**CONCEPTUAL, BASIC and DETAIL DESIGN
ENGINEERING OF STYRENE PARK OFFSITE**

Document Title: P&ID for Basket Filter

Document No. : EI027-ENR-VD-PR-PID-003

Rev.: R2

DRAWING NO.	REV.	SIZE	SCALE	SHEET
EI027-ENR-VD-PR-PID-003	R2	A3	NTS	6 of 8

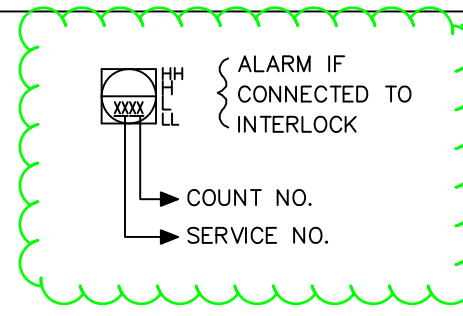
This coding has discrepancy with the instrument tags in P&ID section

PK-0001-A
AIR AFTER FILTER
 TYPE : BASKET
 RATED CAPACITY : 1188 Nm³/hr
 ID x TT : 445 x 1500 mm
 DP INT/EXT : 3.5 barg
 DT : 85.0 °C
 INSULATION : No
 MATERIAL : CS

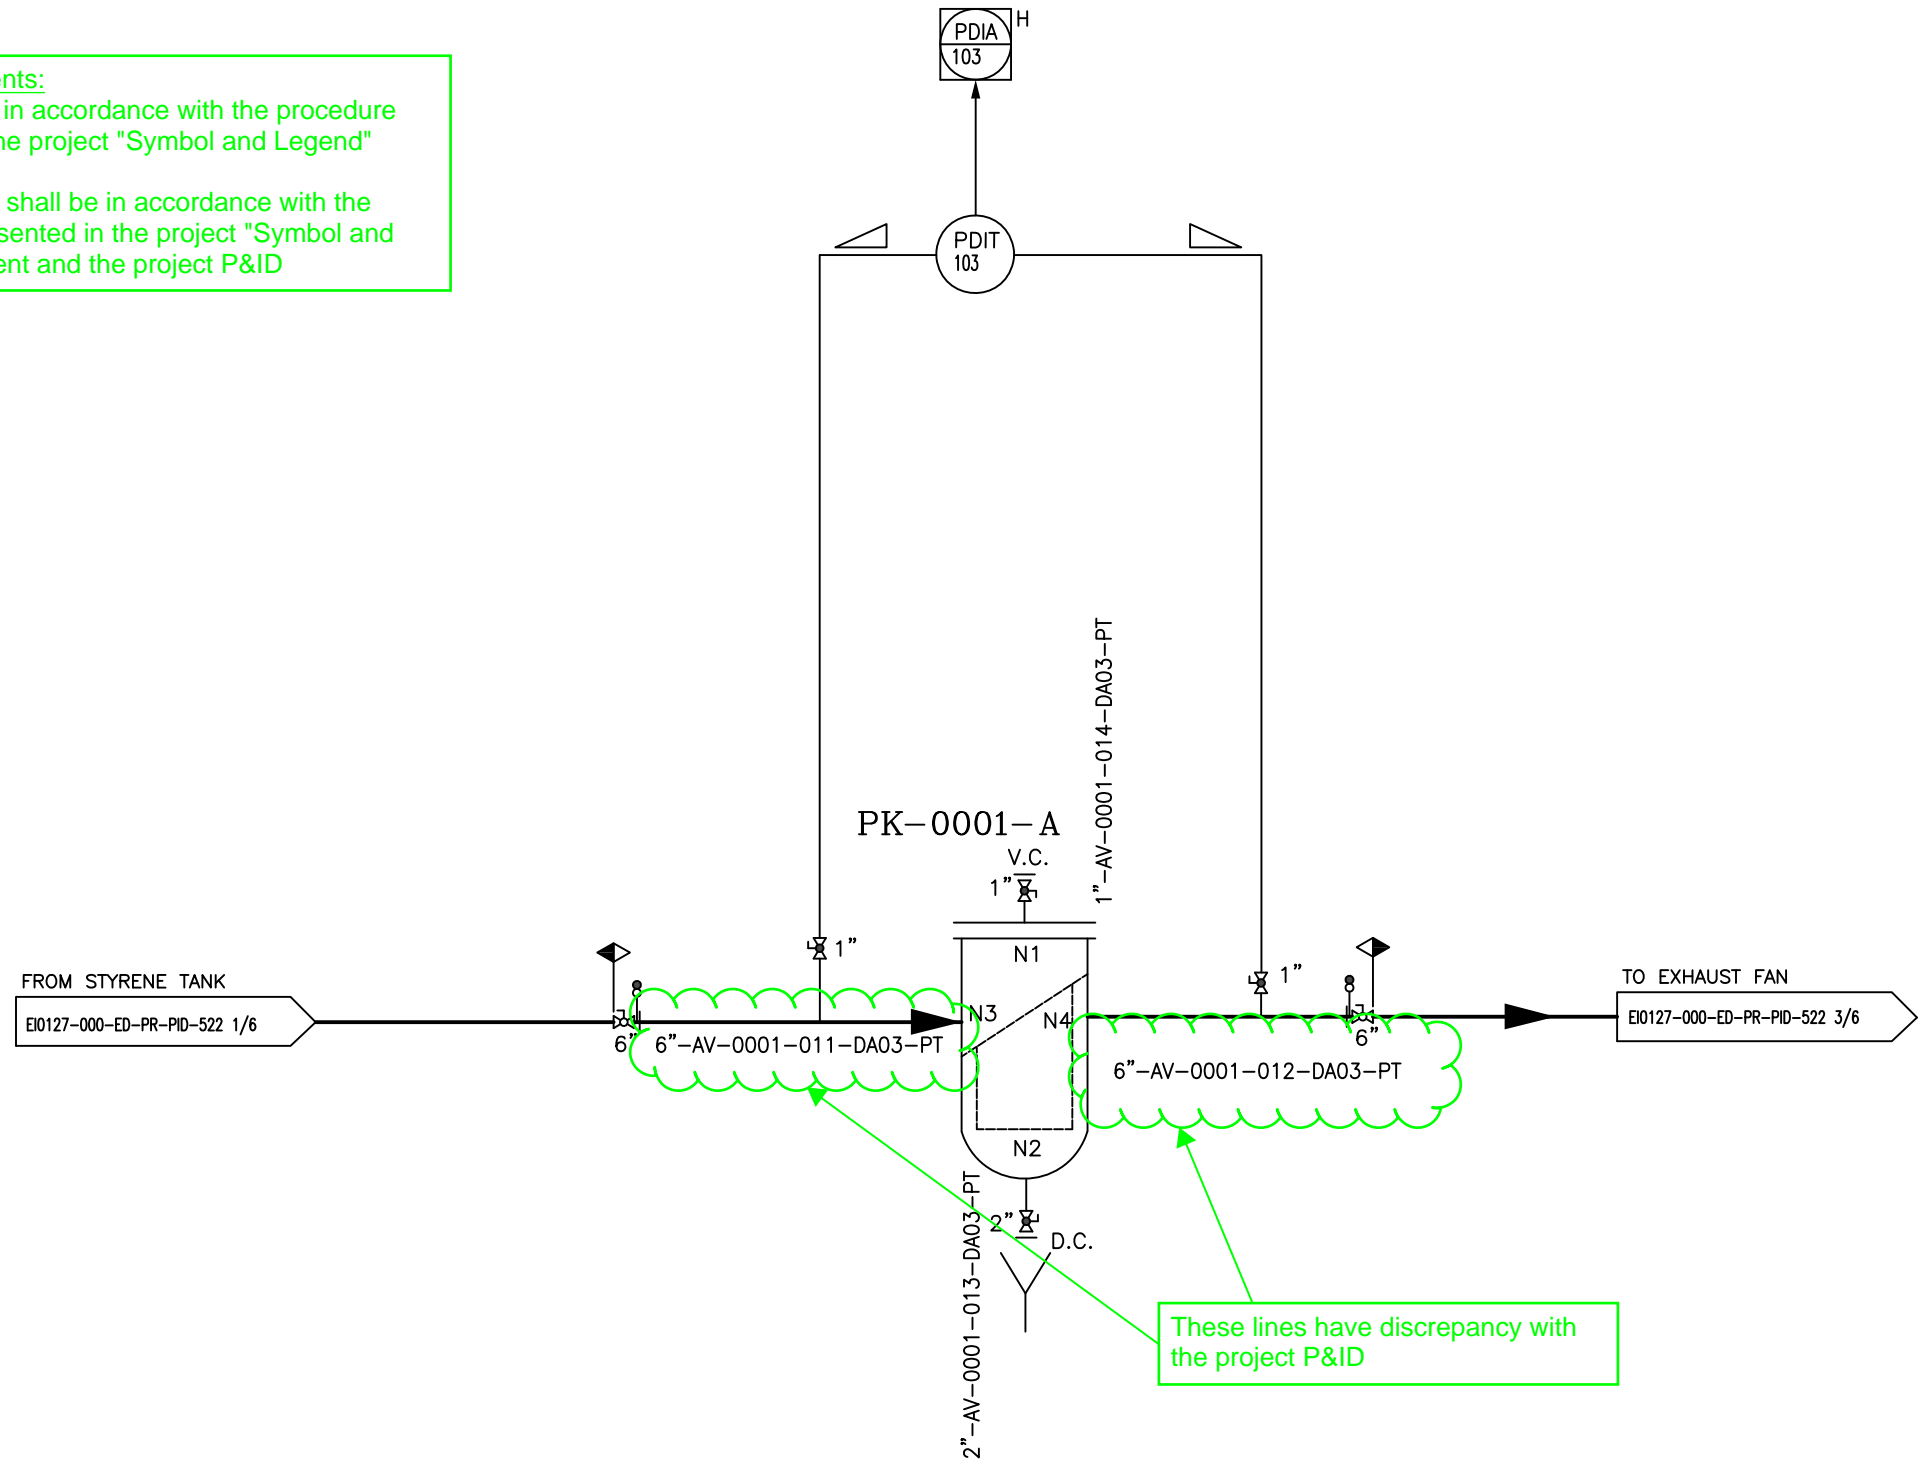
General Comments:
 1- Tags shall be in accordance with the procedure represented in the project "Symbol and Legend" document
 2- Line numbers shall be in accordance with the procedure represented in the project "Symbol and Legend" document and the project P&ID

PK-0001-B
 AIR AFTER FILTER

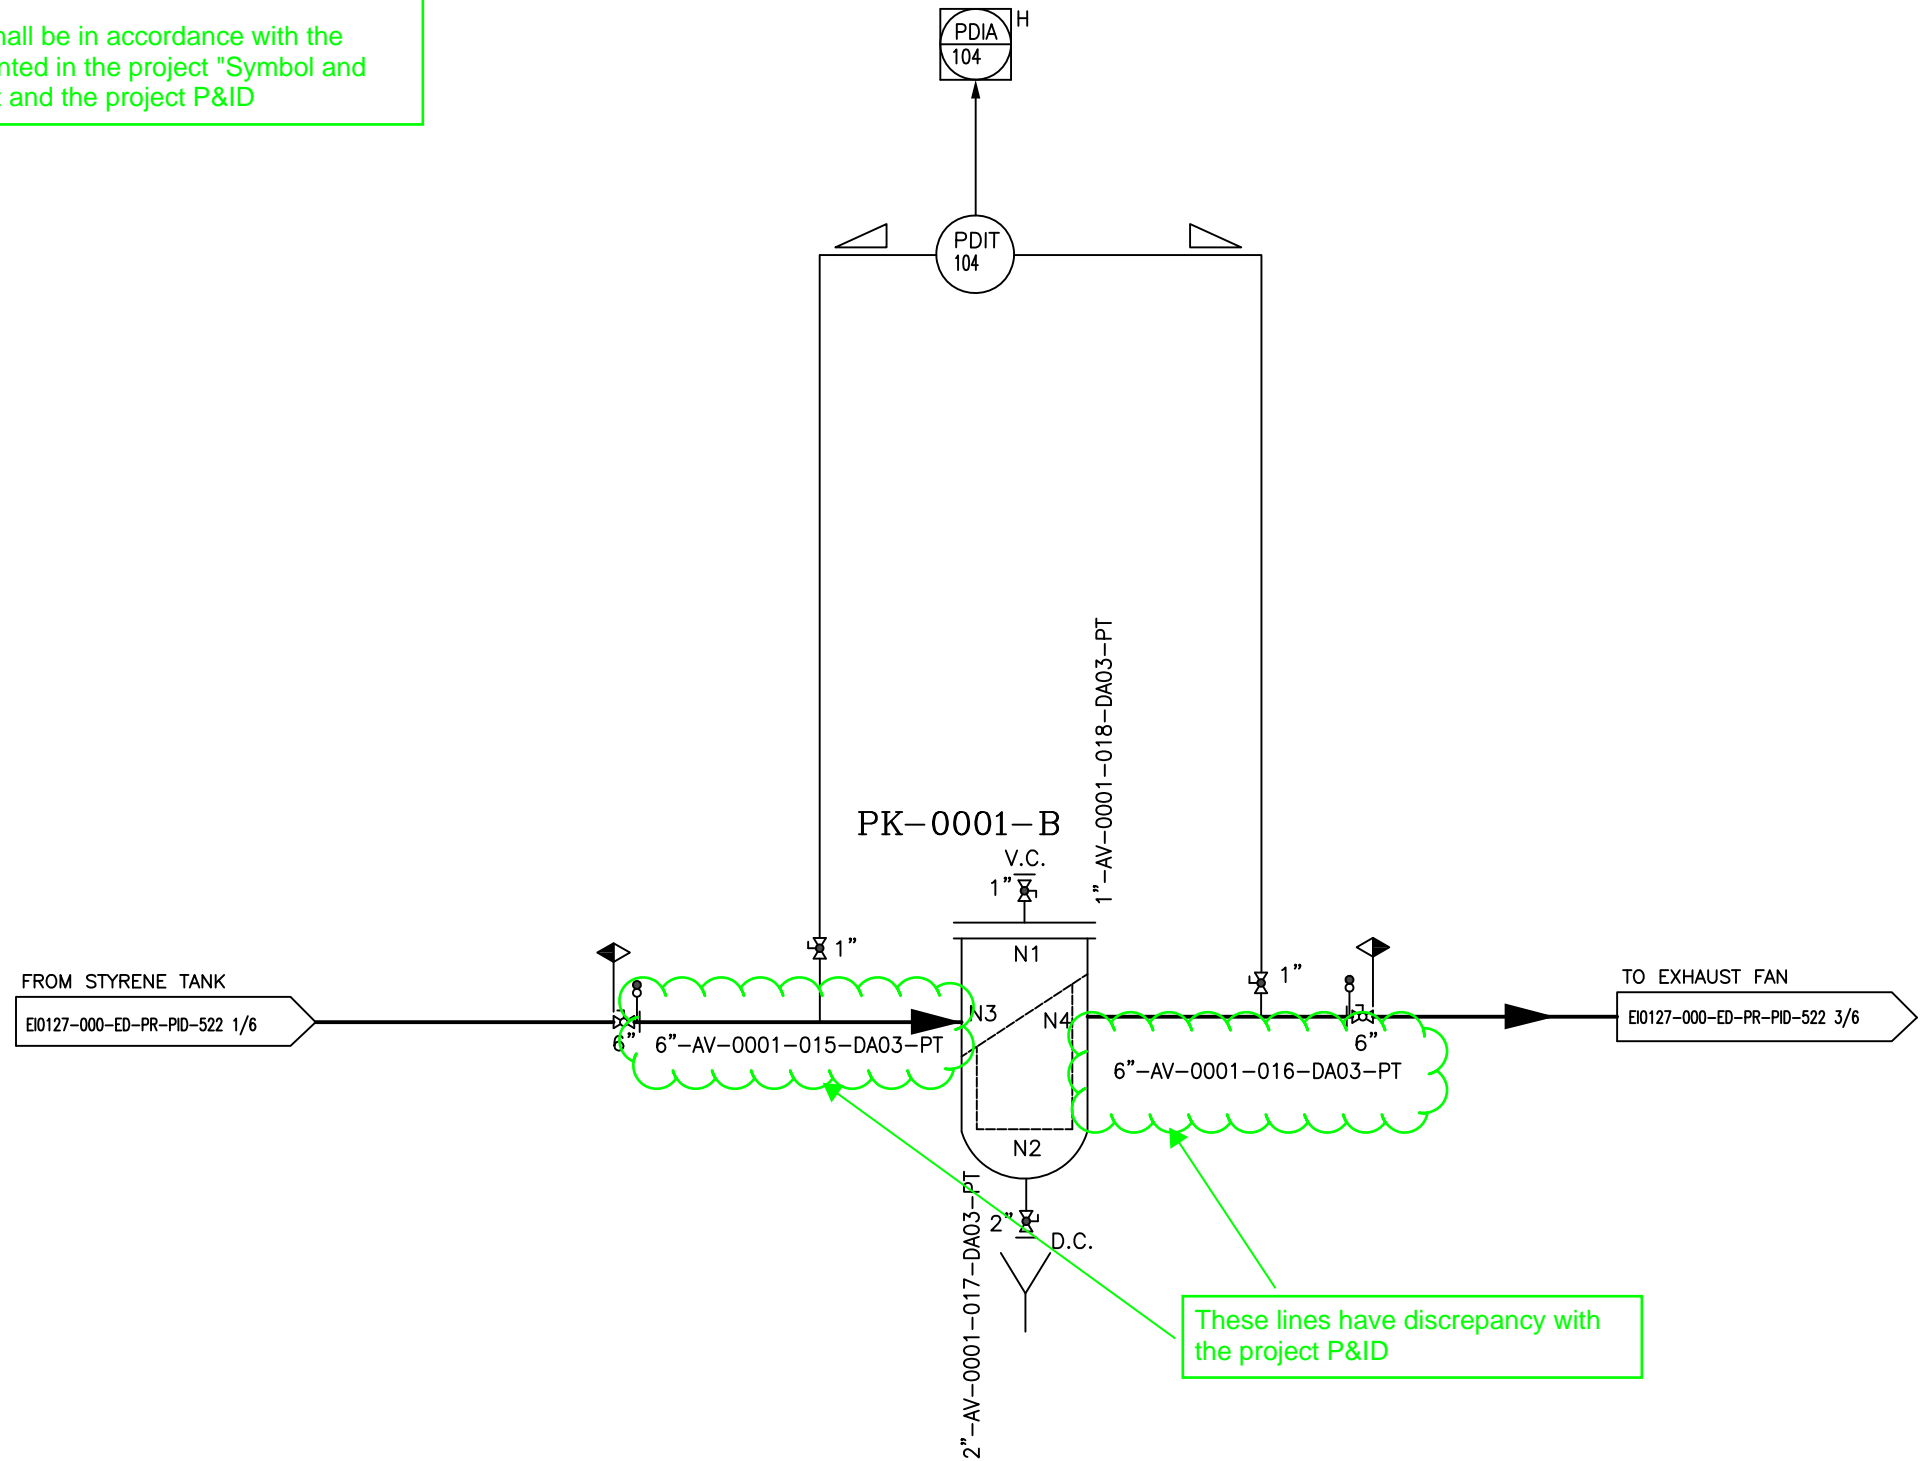
General Comments:
 1- Tags shall be in accordance with the procedure represented in the project "Symbol and Legend" document
 2- Line numbers shall be in accordance with the procedure represented in the project "Symbol and Legend" document and the project P&ID

These lines have discrepancy with the project P&ID
